RE: Progress Energy Florida – Levy Nuclear Project Units 1 and 2
DOAH Case No. 08-2727; DEP OGC Case No. 08-1621; PPSA No. PA08-51
DETERMINATION OF INCOMPLETENESS (*Main Site & Associated Facilities*)

Responses to Comments on Levy Nuclear Plant Units 1 and 2 Site Certification Application for Power Plant and Associated Facilities

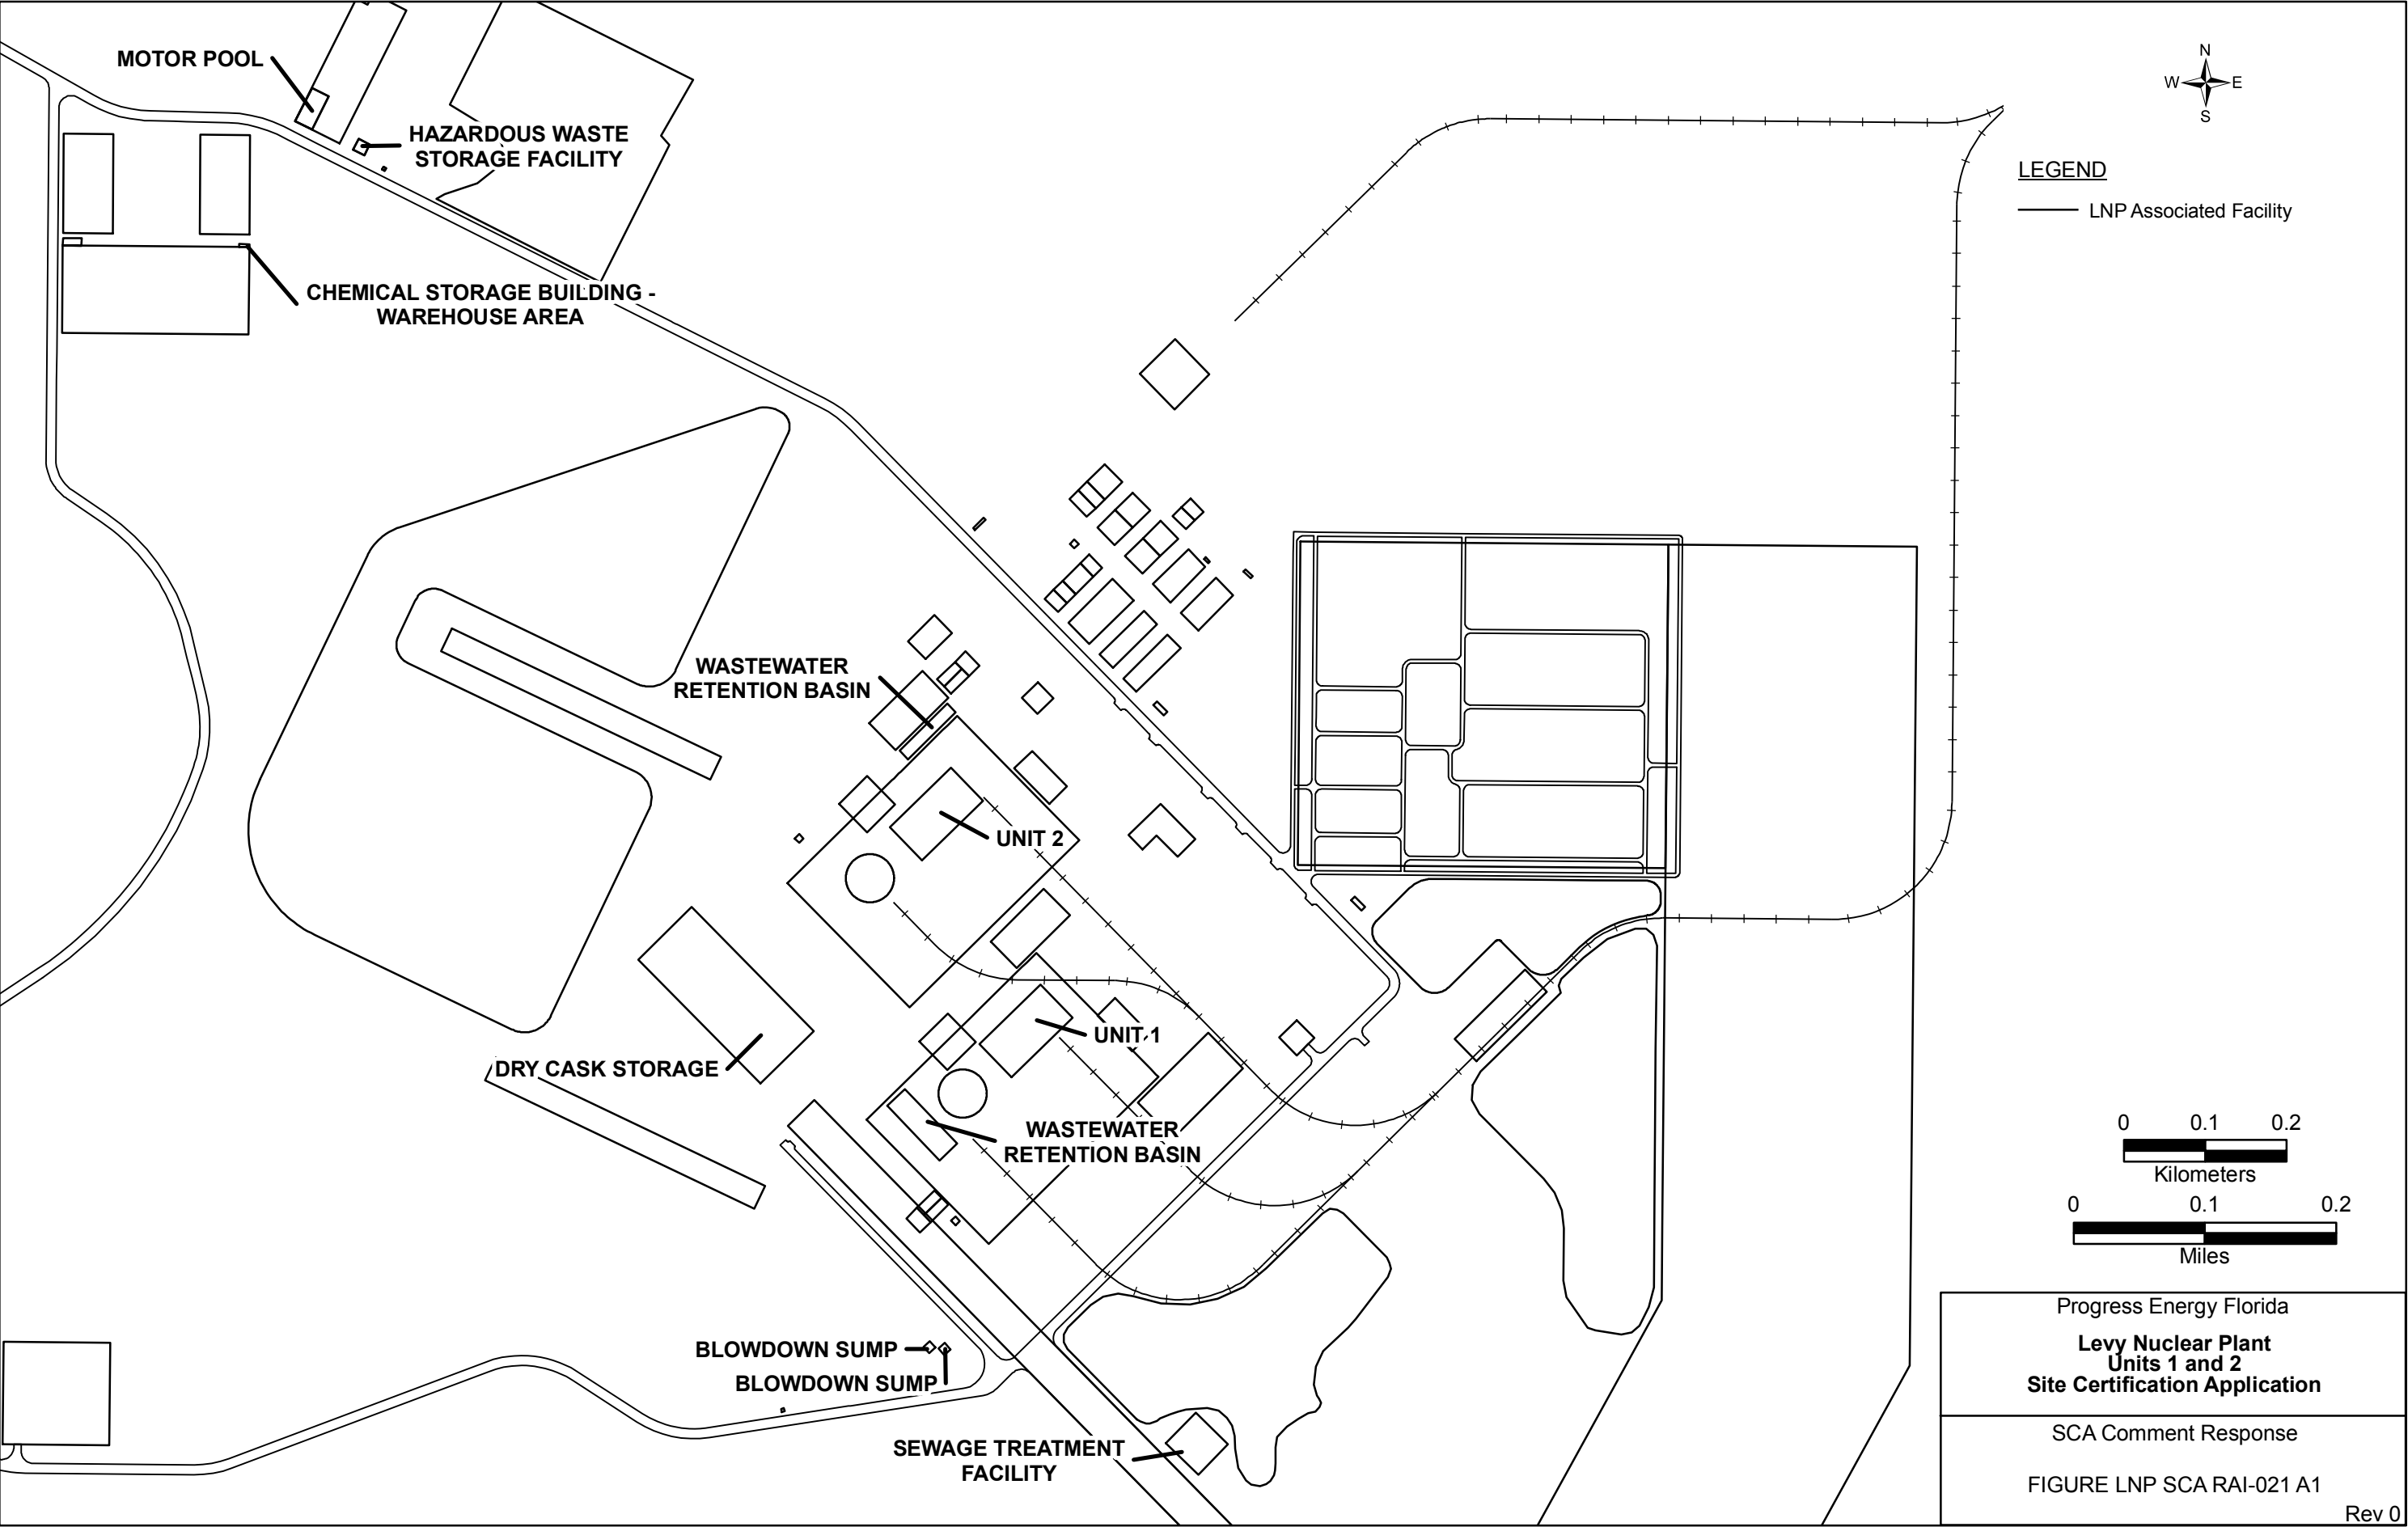
A suitably scaled site plan (maximum 11" x 14") is requested that clearly identifies the locations of all discharge and disposal areas mentioned in the previous item.

EXHIBIT 3
Original and Revised Wellfield Layouts

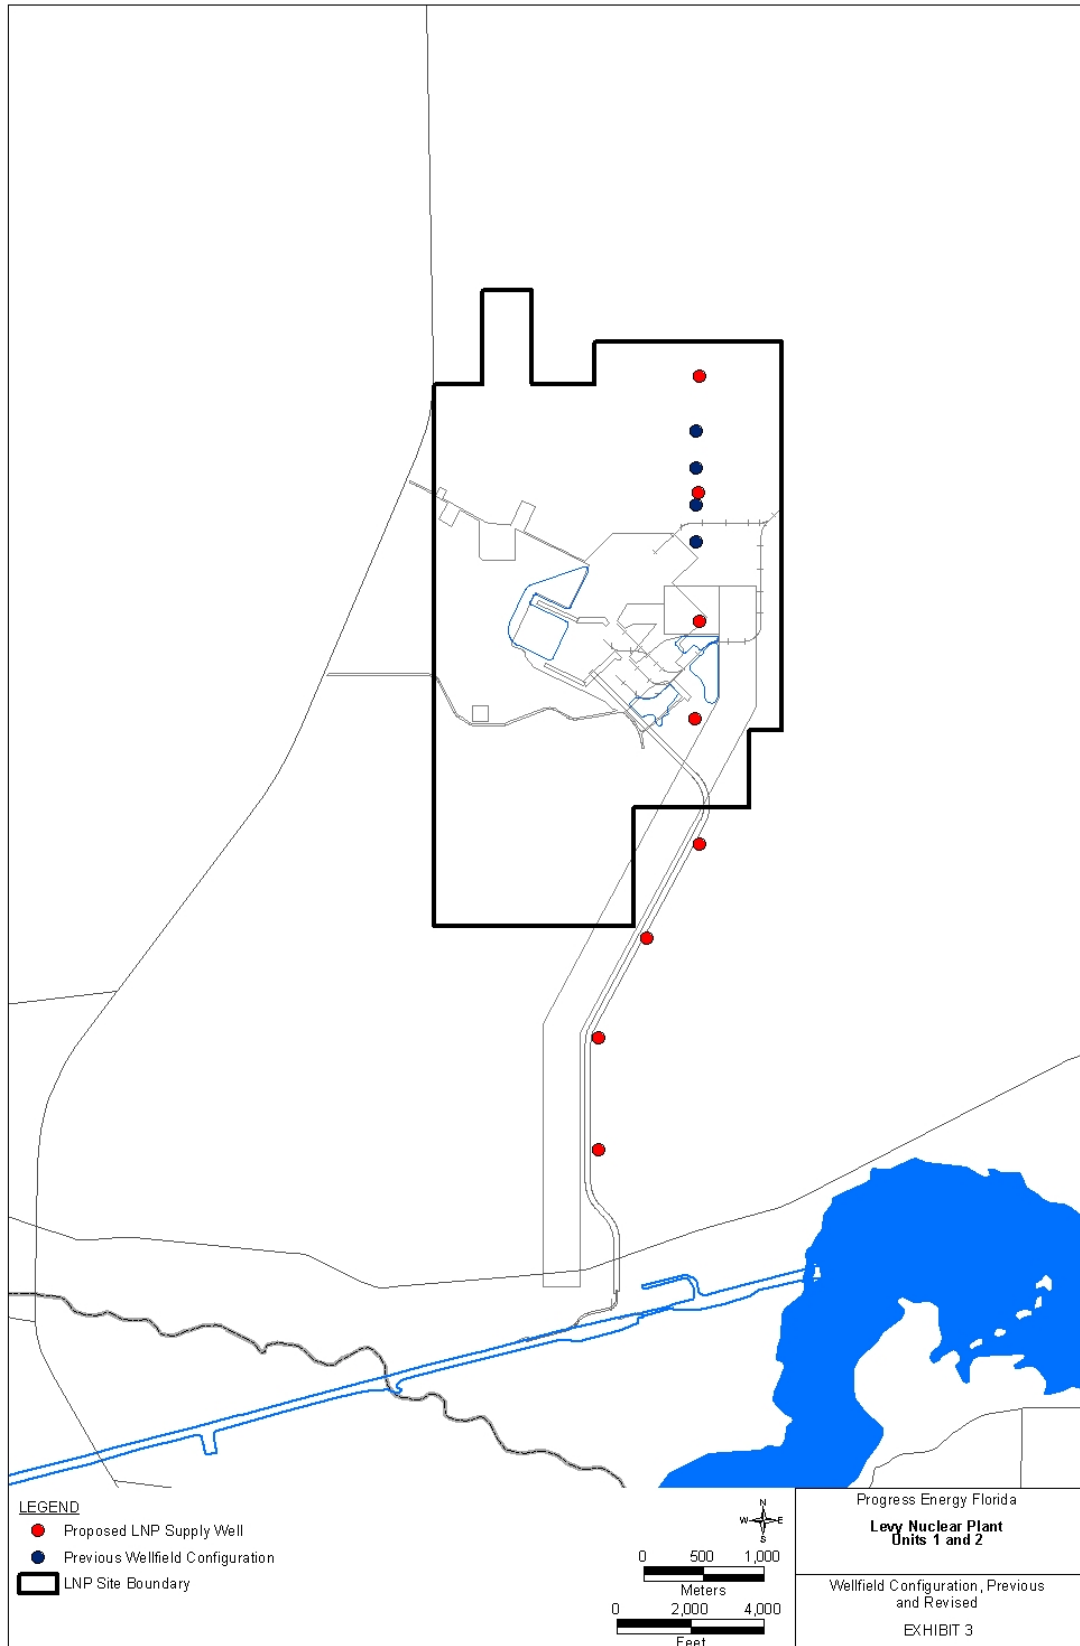
The layout and operation of the proposed wellfield was also modified. The original wellfield layout included 4 wells on 1,000 ft spacing located northeast of the plant. The new conceptual wellfield layout includes eight wells, running in a north-south alignment with approximately 3,000 ft well spacing. The wells are positioned east of the haul road and power transmission corridor south of the main plant, and then to the west of the transmission corridor north of the bend in the haul road. Exhibit 3 depicts the original and revised wellfield layouts.

EXHIBIT 12
Simulated Incremental Surficial Aquifer Drawdown and Wetlands, Average-Day Conditions

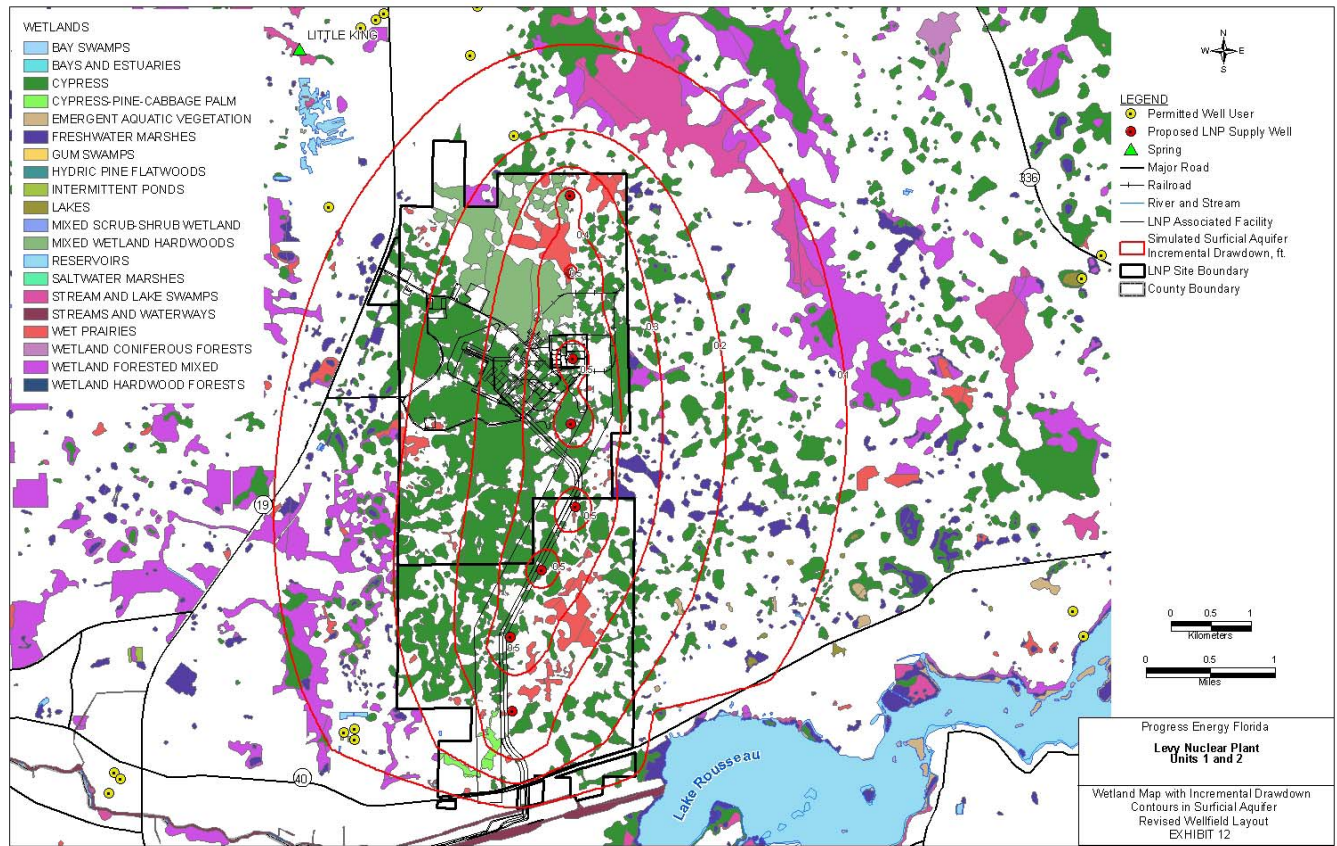
The incremental SAS drawdown effects from pumping the UFA are below 0.5 ft throughout the wellfield and site, and approximately by the same amount in the immediate vicinity of the wells located in the middle of the plant site (Exhibit 12). With the reduced SAS drawdown predicted from the model, the wet season water level of the on-site wetlands is expected to remain within the normal range of water levels, and the hydroperiods of these wetlands are expected to remain within a normal range and duration. Exhibit 19 summarizes the acres of wetlands (by FLUCCS code) that fall within the incremental 0.5 contour depicted by Exhibit 12.
